ENVIRONMENTAL REVIEW TEAM REPORT

PLYMOUTH HEIGHTS SUBDIVISION PLYMOUTH, CONNECTICUT

MAY 1980

FIGURE 2.
SIMPLIFIED SITE PLAN

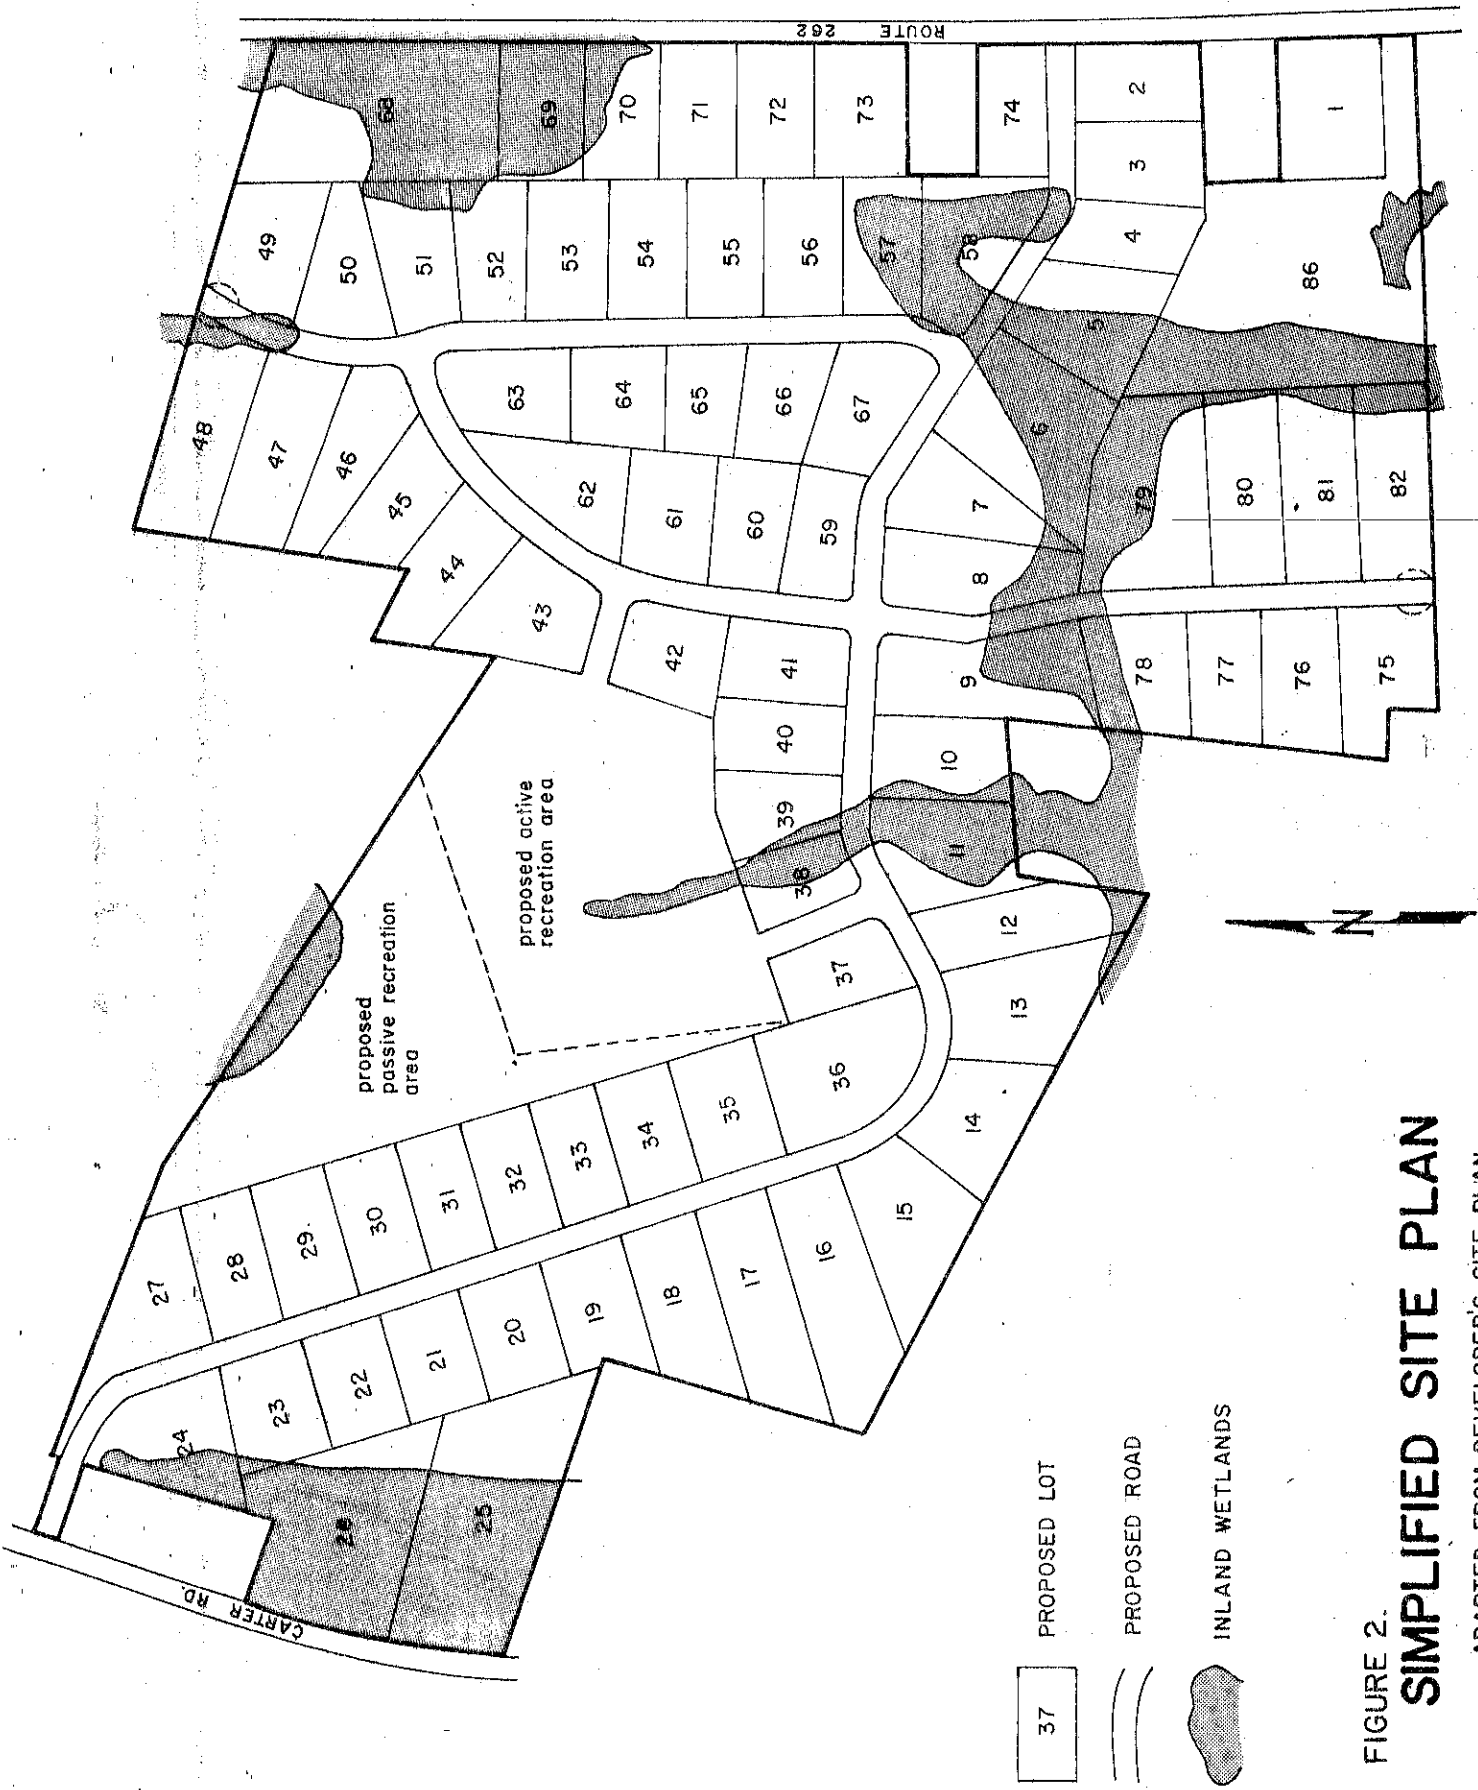
The preliminary subdivision plan for "Plymouth Heights" calls for 83 residential lots of 1 to 5+ acres in size. Most of the proposed lots are 1 to 1.5 acres in size. The project plans also call for a + 9 acre "passive recreation area" and a + 9 acre "active recreation area". Access to the proposed lots would be created by constructing an interior road network between Route 262 and Carter Road. Figure 2 shows a simplified site plan of the development proposal.

In the western half of the site, runoff problems would occur mostly as a function of the steep slopes and the cuts and fills that would be required for development. Indeed, the location of the road in that section, as presently planned, would require a slope at or exceeding 10 percent, and with the topography as steep as it is, it is difficult to conceive of any road layout that would improve upon this slope. Development would need to be exceptionally carefully planned in this section in order to avoid serious erosion and mass-movement (large scale sliding of overburden) problems.

Runoff problems associated with the northeast section of the site should, by comparison with the other two sections, be minimal, as the slopes are more moderate. The wetland in the northeastern corner should serve as a natural retention area for runoff, mitigating any increases in flow rates. Because of the proximity of bedrock to the surface in this area, however, water quality effects may be a more serious consideration. Septic systems will need to be carefully sited or engineered on the various lots to assure adequate renovation of effluent in the soil. Placement of leaching fields in soils of inadequate depth or soils having a seasonally or permanently high water table may lead to surfacing of effluent in the wetland area, with the attendant health and aesthetic problems. It seems particularly unlikely that a septic system could be adequately sited in proposed lot 69.

FIGURE 3.
 BEDROCK OUTCROPS OBSERVED ON THE PLYMOUTH
 HEIGHTS SITE. (Does not include all outcrops on the site.)

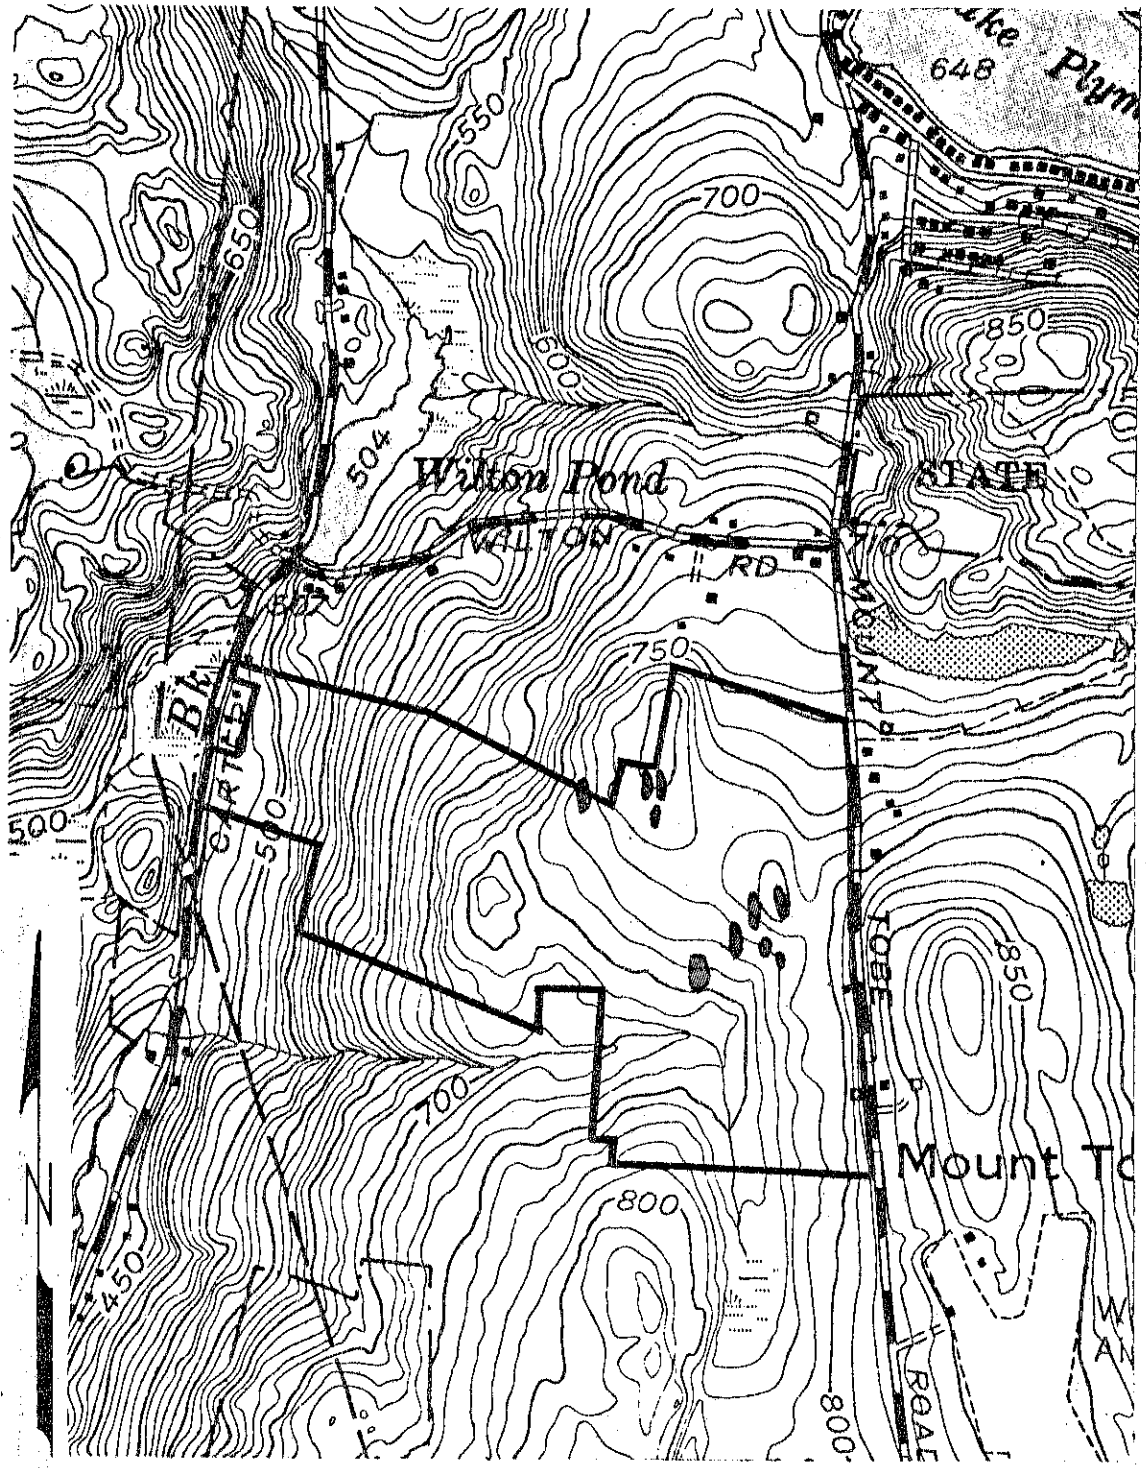
Bedrock outcropping on the site consists primarily of a lustrous, silvery hornblende-quartz mica schist. Outcrops were observed mostly in the open fields, but the numerous boulders and the steep slopes on the western side of the property suggest the proximity of bedrock to the surface in that area as well. Boulders at the extreme western edge of the site were slightly more varied in lithology, but mica schist was still the dominant rock type. Occasional boulders of garnet-studded amphibolite were found in all sections of the property. A few large boulders of pegmatite were noted in the open fields. Figure 3 shows the location of the bedrock outcrops observed on the site.

FIGURE 4.
DEVELOPMENT LIMITATIONS MAP

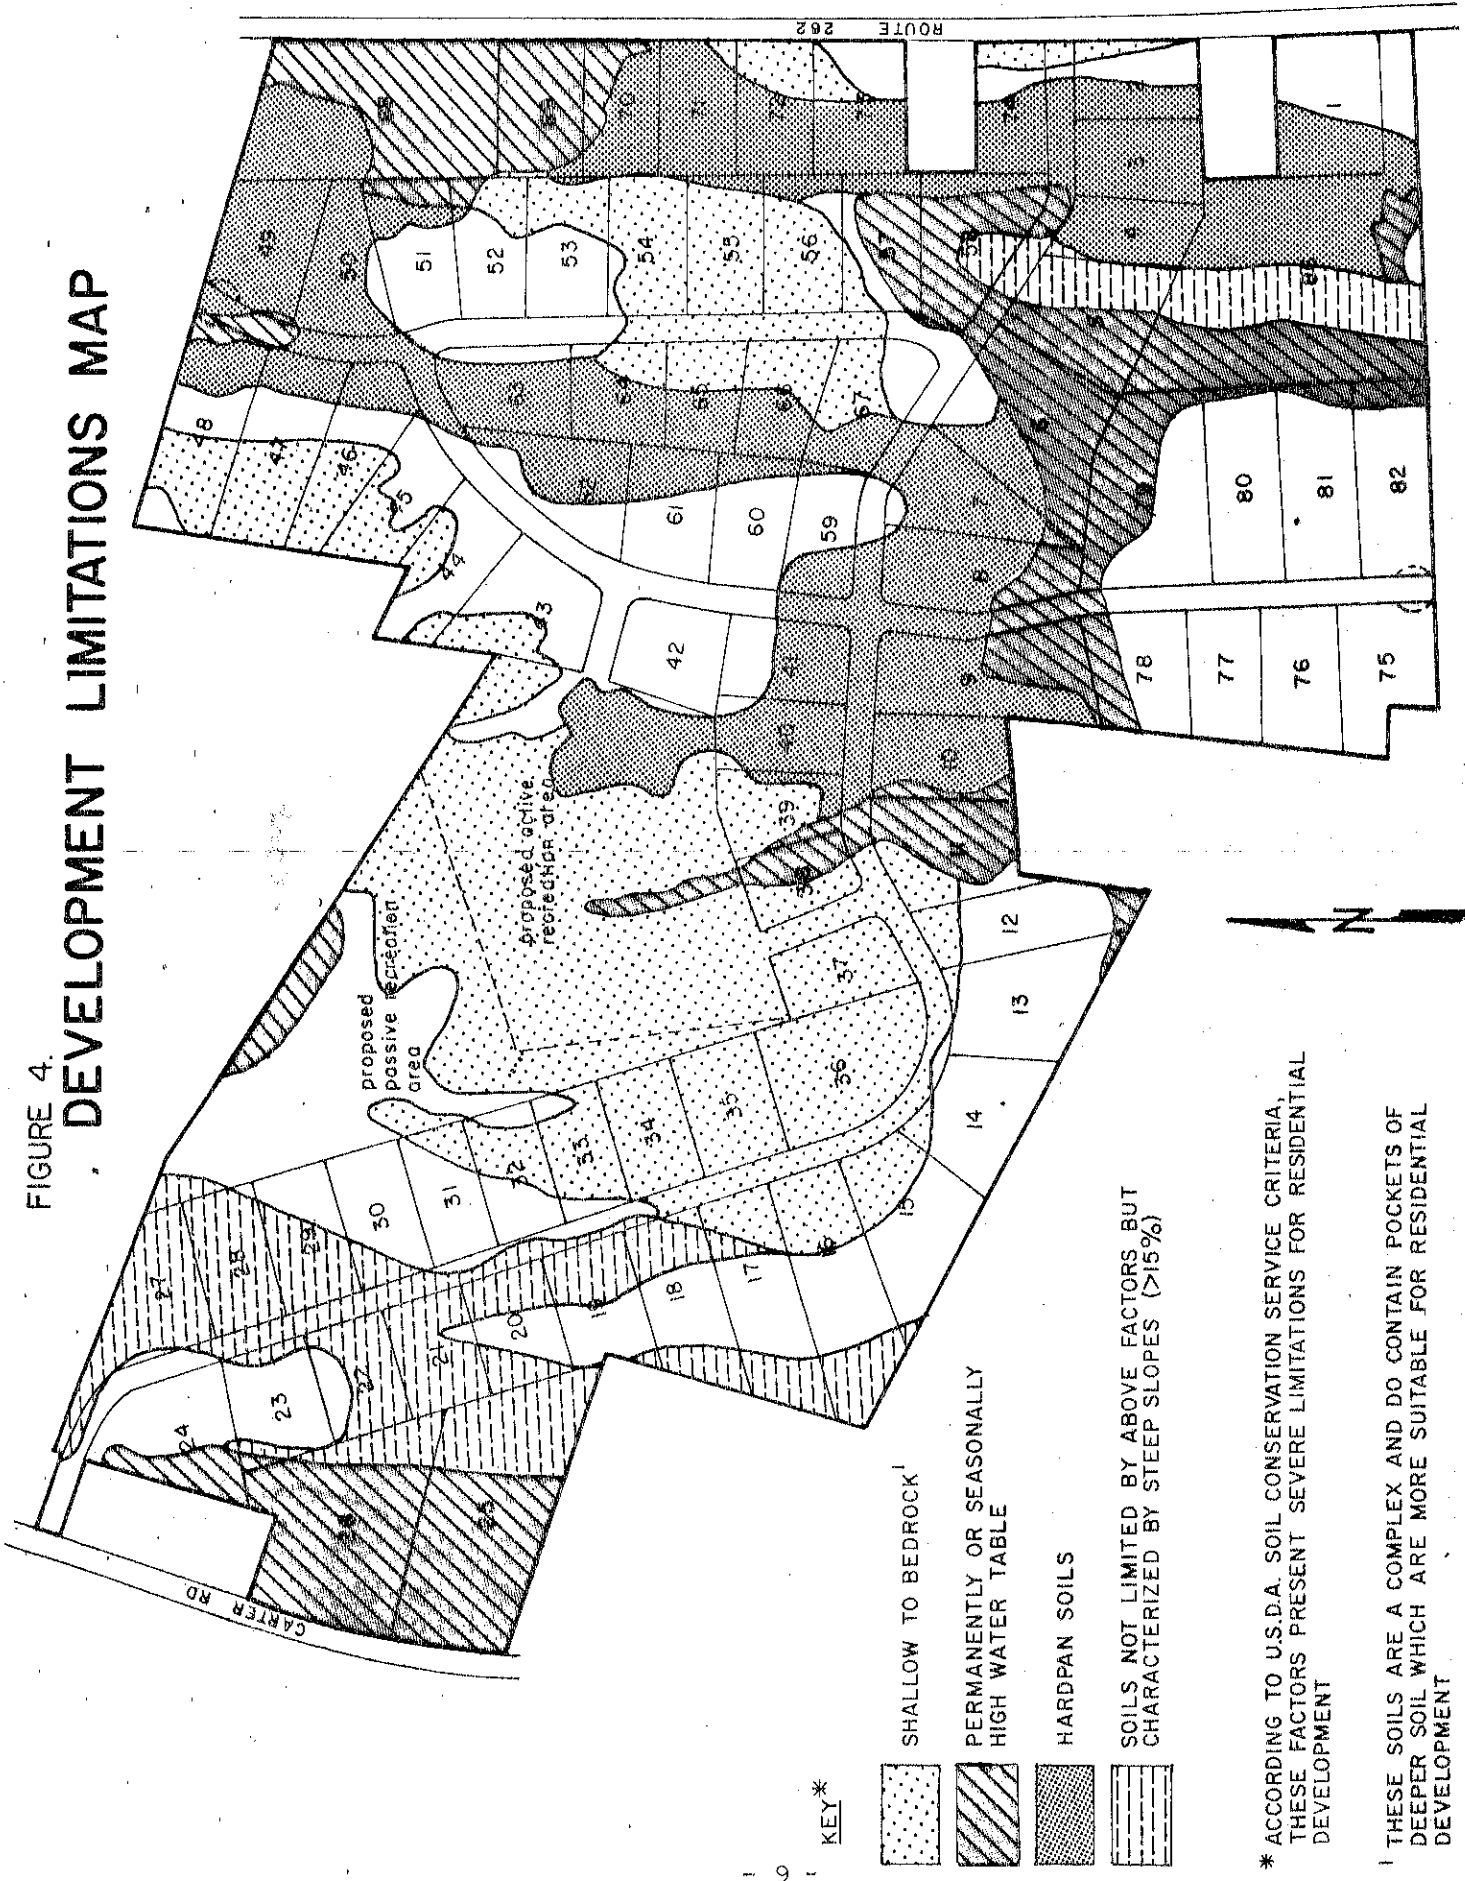
As shown in Figure 4, most of the Plymouth Heights property has severe limitations for residential development according to USDA Soil Conservation Service criteria. Major limiting factors include shallow to bedrock soils, wetness, hardpan soils, and steep slopes. Although a severe rating by the SCS does not necessarily preclude development of the property as planned, it does indicate that very careful site planning and design will be required to avoid significant environmental harm. In addition, extensive and costly measures will undoubtedly be required to overcome the natural limiting factors of the land. For example, several of the lots on this parcel will be difficult to develop with homes having full basements. Shallow depth to bedrock, wetland proximity and seasonally high water tables may necessitate blasting, filling, and/or footing drains. As discussed later in this report, extremely careful engineering will be required on

much of this site for proper septic system installation and operation. It should also be noted that shallow depth to bedrock increases the possibility that septic effluent may reach bedrock fissures and consequently enter bedrock wells. The proposed density of development on the shallow to bedrock soils increases this possibility.

FIGURE 6.
VEGETATION TYPE MAP

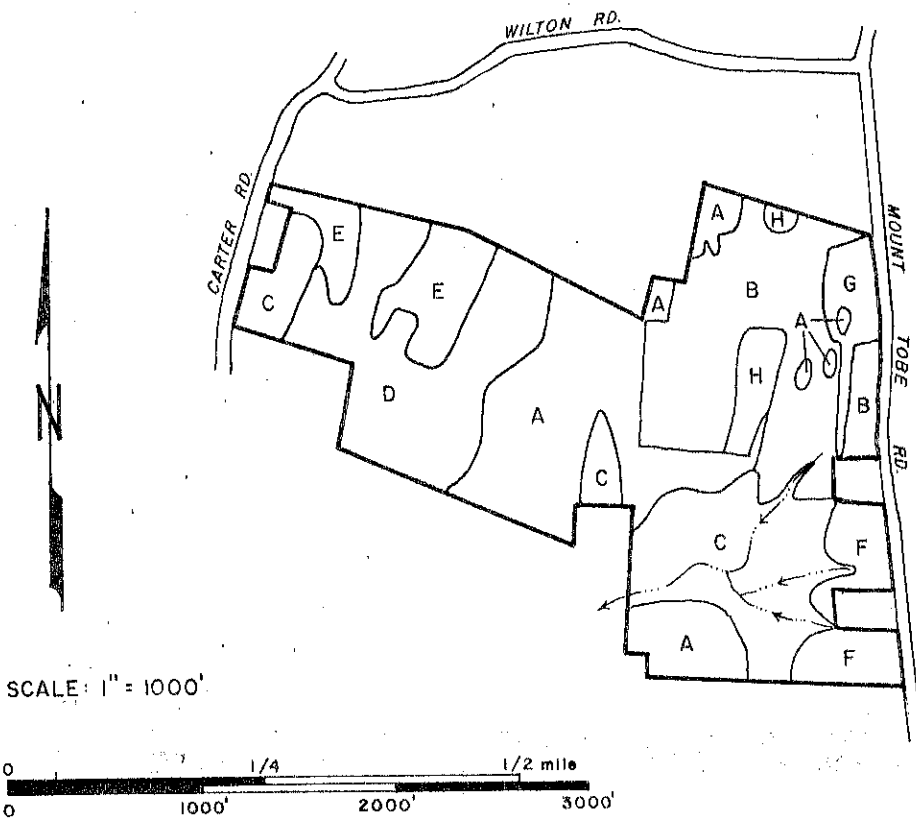
Open Fields. This area is shown as stand B in Figure 6 and has high value for wildlife. Wildlife benefit will be largely lost with development of this area due to habitat loss. Many species presently utilizing this area will not be able to following the proposed development.

Old Reverting Fields. This area, shown as stand E in Figure 6, offers the best of all wildlife habitat on the property. Road and housing development will greatly reduce its value. Time will also reduce its value if not managed as wildlife habitat; however, several years would be involved for plant succession to reduce the areas value significantly.
